May 29, 2025

**Re: PR# 69-2025 – Residual Maintenance Chlorination
Western Christian School (PWS ID# 90582)
Conditional Approval**

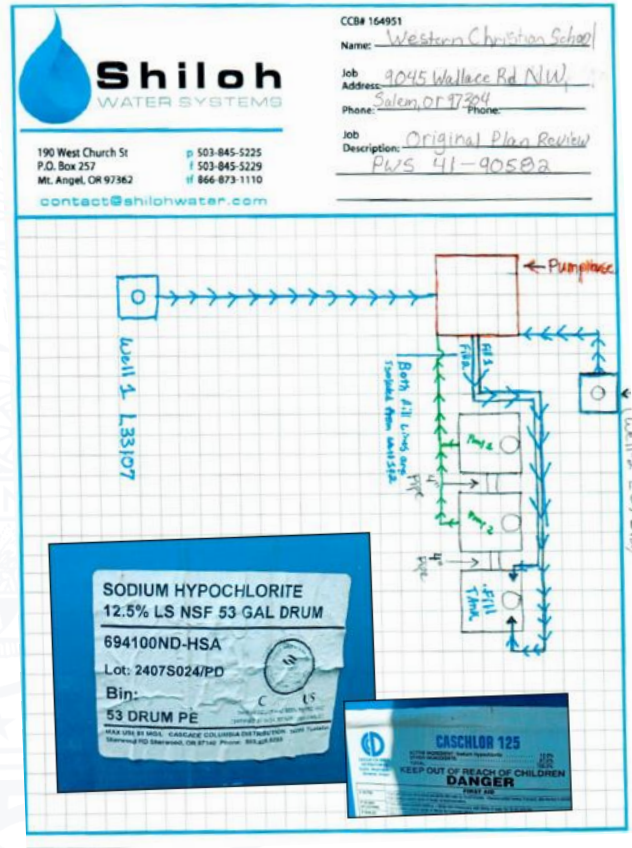
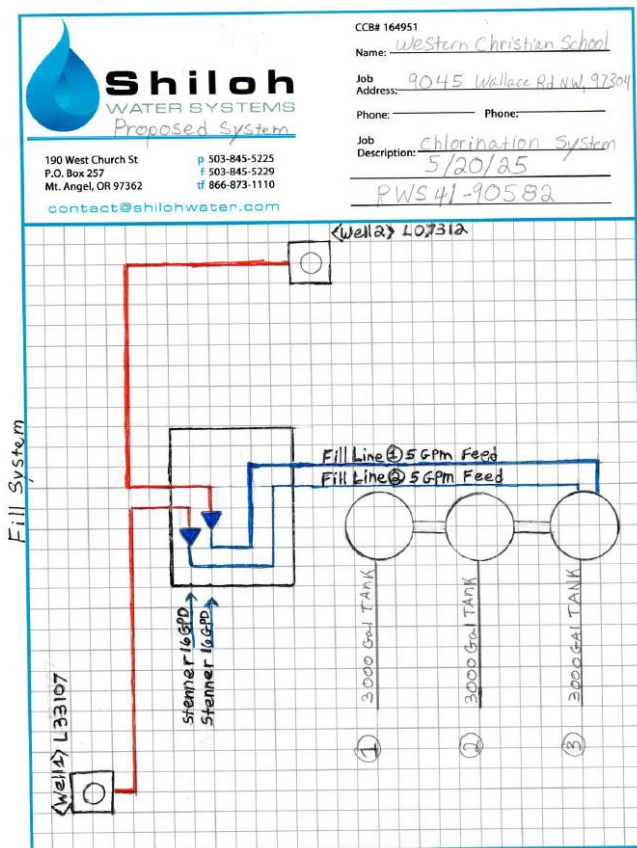
- ☐ Confirm and submit more details on the piping configuration for the tanks.
- ☐ Describe how the rate of flow leaving the storage tanks is accomplished (this is typically either through one or more tank effluent flowmeters or based on the pumping rate of pumps used to transfer water from a tank to the distribution system).
- ☐ Provide the maximum anticipated demand flow leaving the tanks in gpm.
- ☐ Ensure the tanks are inspected, and any breaches or deficiencies are addressed in such a way as to prevent insects, rodents, infiltration of groundwater from the surrounding soils, and rainwater or surface runoff from entering any of the storage tanks. Please submit information on the breaches or deficiencies found and the corrective action taken.
